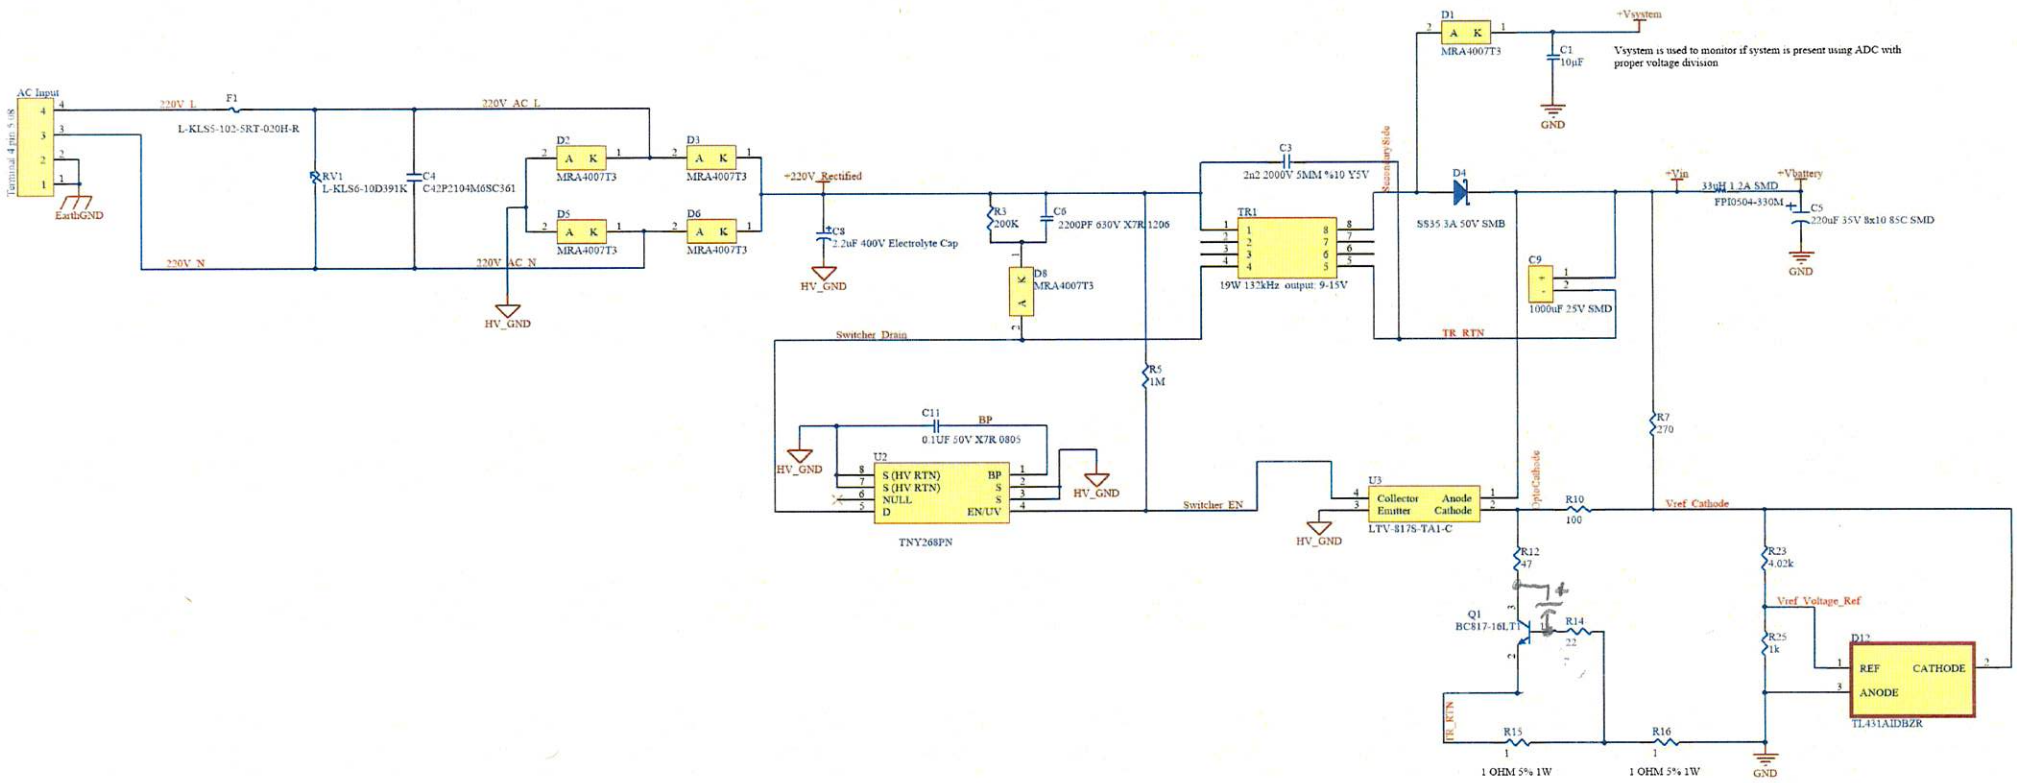
Make R14 larger, maybe 100Ω or so.
